# UTILITY CONFORMANCE LETTER

**Subject:** Overland Ranch Filing 2 – Utility Conformance Letter

Aurora Water - Utilities comments  
by Iman Ghazali  
([ighazali@auroragov.org](mailto:ighazali@auroragov.org))

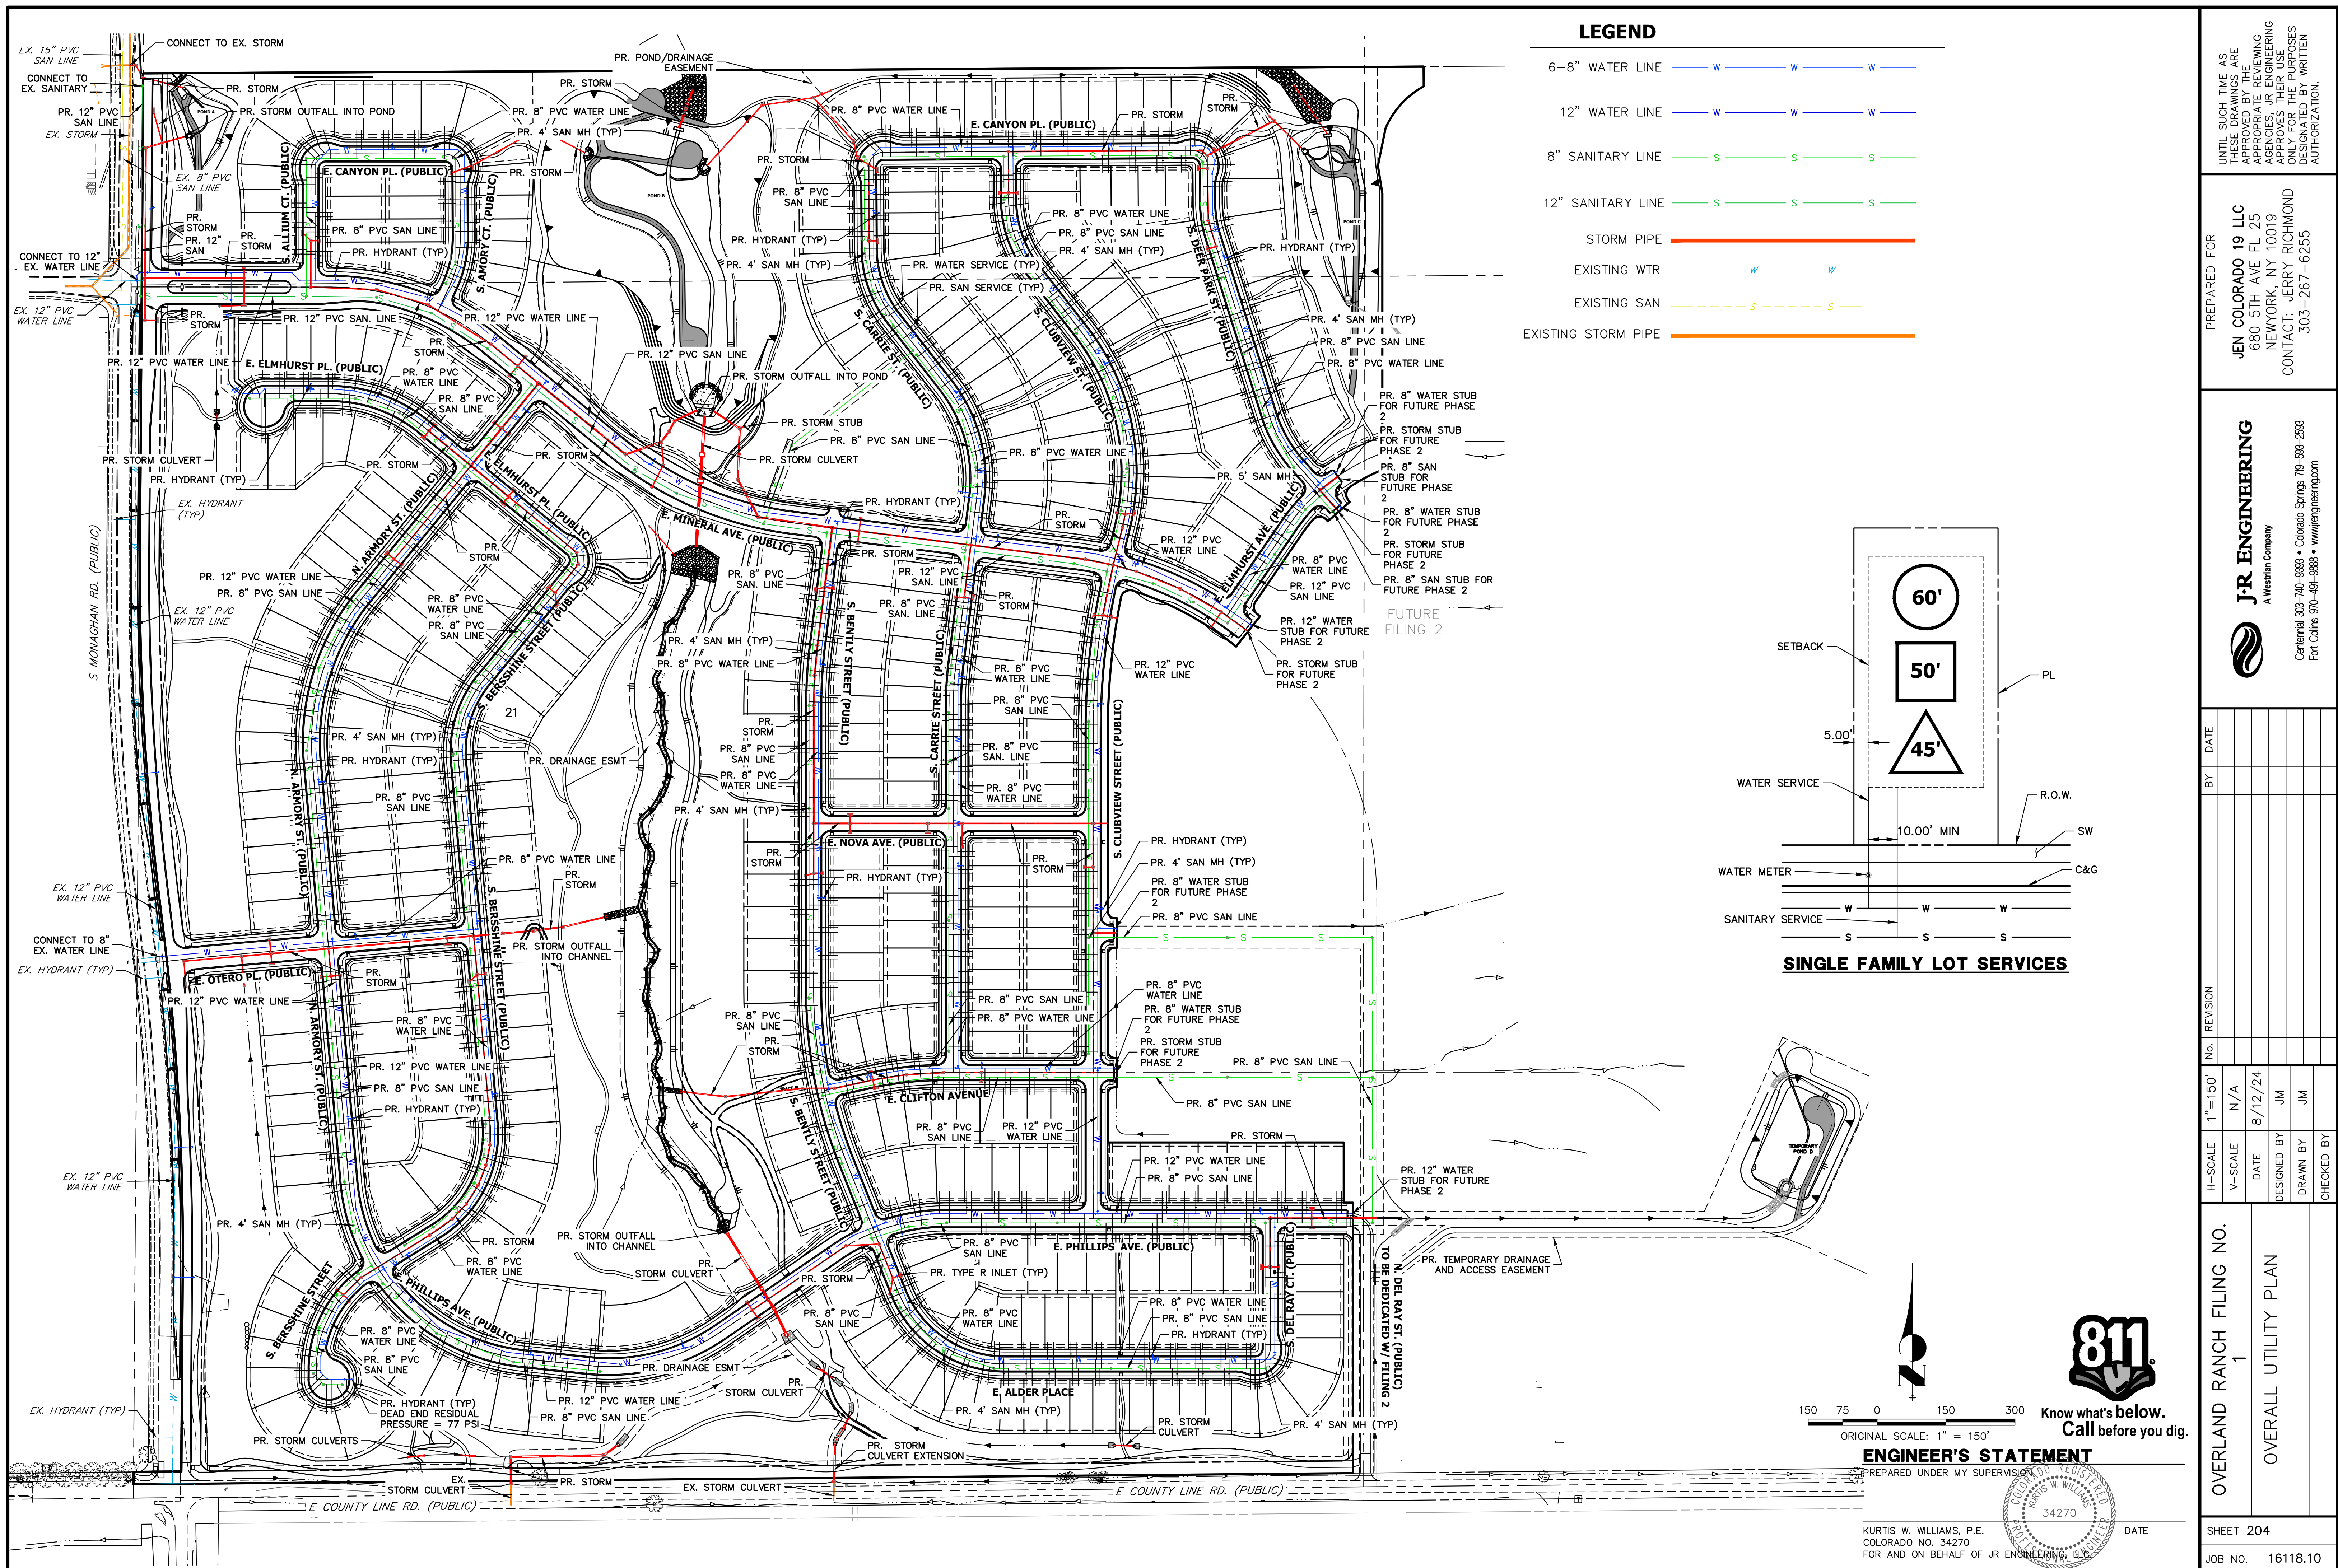
Revise calcs per comment on the previous sheet

Per MUS, this should be 1037 and 2873 respectively

UPDATED to be consistent. used the values in the specified after communications with Iman in late January

UPDATED calcs per the comment on the previous sheet
